# Access Compliance Report

## Public Rights-of-Way

Intersection ID: 10034609	Main Street: PLANTATION_CENTER_DR	Cross Street: N/A	Location: SE
ADA ID: B2EF171C33C2	Ramp Type: Para	Initial Pass/Fail: Fail	Overall Compliance: No
Codes/Mitigation Info/Possible Solution		Field Measurements/Component Compliance	
Severity Score: 13.75

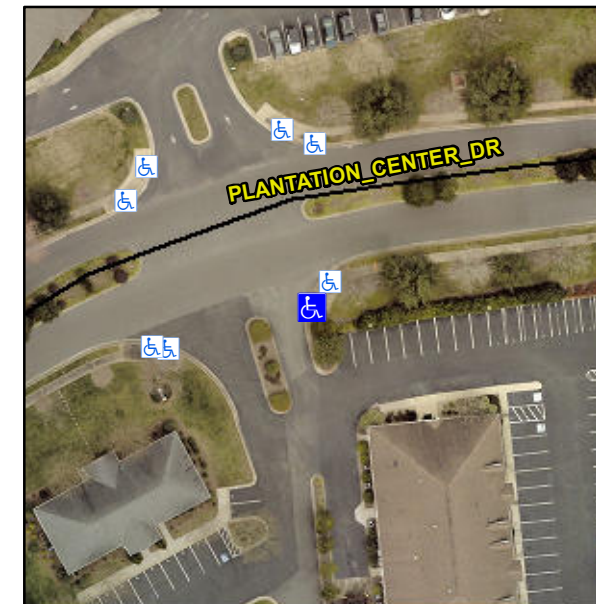
**R304.5.3, R304.3.2**

Compliance	Description	Data	Compliance	Description	Data
N/A	Ramp Length LT (in)	41.0	N/A	Ramp Length RT (in)	51.0
Yes	Ramp Width LT (in)	108.0	Yes	Ramp Width RT (in)	108.0
Yes	Ramp Slope LT (%)	4.2	No	Ramp Slope RT (%)	9.8
No	Ramp XSlope LT (%)	3.6	Yes	Ramp XSlope RT (%)	1.7
N/A	Landing Length (in)	N/A	N/A	DWS Provided?	N/A
N/A	Landing Width (in)	N/A	N/A	DWS Contrast?	N/A
N/A	Landing Slope (%)	N/A	N/A	DWS Length (in)	N/A
N/A	Landing X Slope (%)	N/A	N/A	DWS Full Width?	N/A
N/A	Landing Curb? (Y/N)	N/A	N/A	DWS Offset (in)	N/A
N/A	Shared Landing?	N/A			
N/A	Gutter Ponding?	N/A	N/A	Gutter Slope (%)	N/A
N/A	Gutter Lip Ht (in)	N/A	N/A	Gutter X Slope (%)	N/A
N/A	Painted X Walk1?	No	N/A	Painted X Walk2?	N/A
	X Walk 1 Direction	To SW		X Walk 2 Direction	N/A
N/A	X Walk 1 Width (in)	N/A	N/A	X Walk 2 Width (in)	N/A
	X Walk 1 Slope (%)	4.1		X Walk 2 Slope (%)	N/A
	X Walk 1 X Slope (%)	3.0		X Walk 2 X Slope (%)	N/A
N/A	Ramp inside XWalk1?	N/A	N/A	Ramp inside XWalk2?	N/A

**Remove & Replace Entire Ramp.**
